PLANT NAME: Turkey Point # 3 & 4

ENCLOSURE  
Proposed Amdt. to OL/Change to Tech. Specs:  
Consisting of revisions to Tech. Spec, with  
regards to Control Rod and Power Distribution  
Limits.....W/Attachments

Re: Turkey Point Units 3 and 4  
Docket Nos. 50-250 and 50-251  
Proposed Amendment to Facility  
Operating Licenses DPR-31 and DPR-41

FIGURE 3.2-1

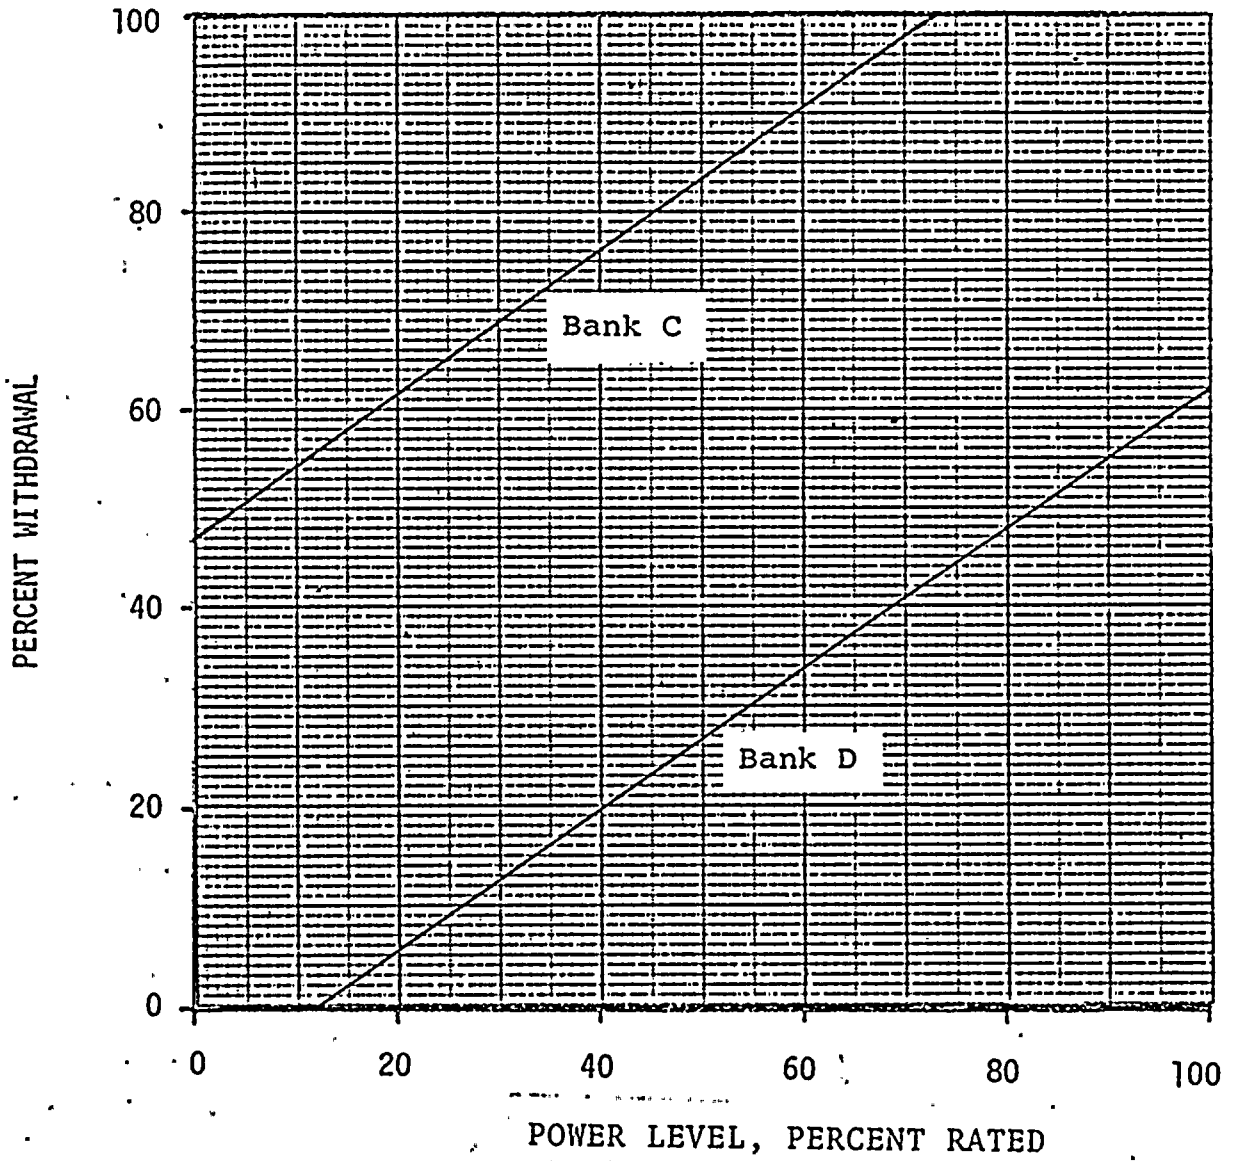
Figure 3.2-1

The control group insertion limit graph for Unit 4 three loop operation is revised to be consistent with one insertion

limit which is applicable for the entire cycle. The revised graph is identical to the dashed-line portion of the Cycle 2 graph.

FIGURE 3.2-1(a)

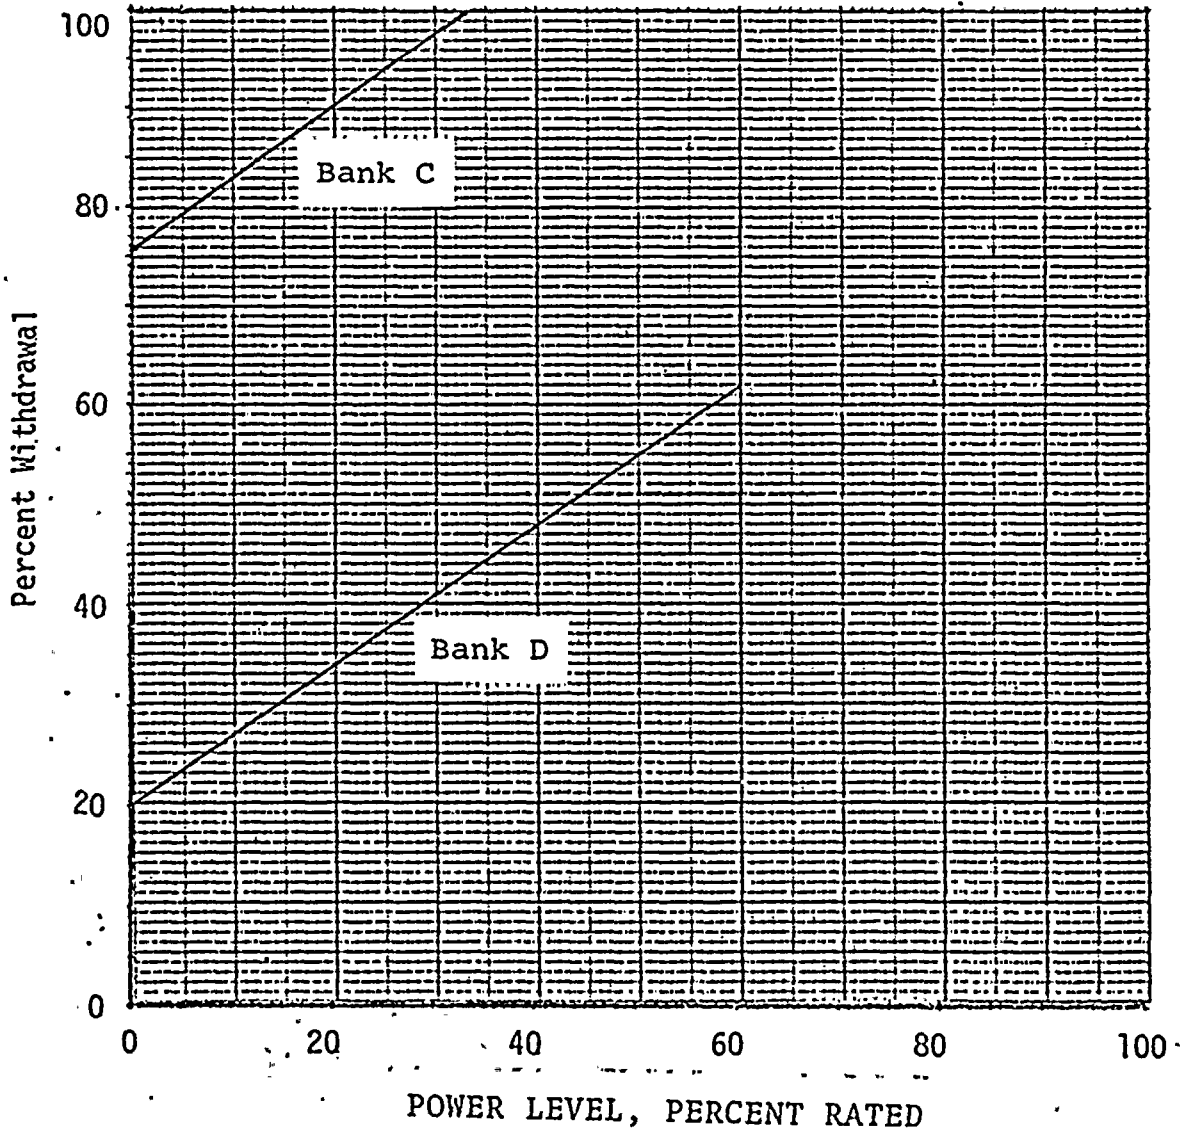
Figure 3.2-1(a)

More conservative control group insertion limits are provided for Unit 4 two loop operation.
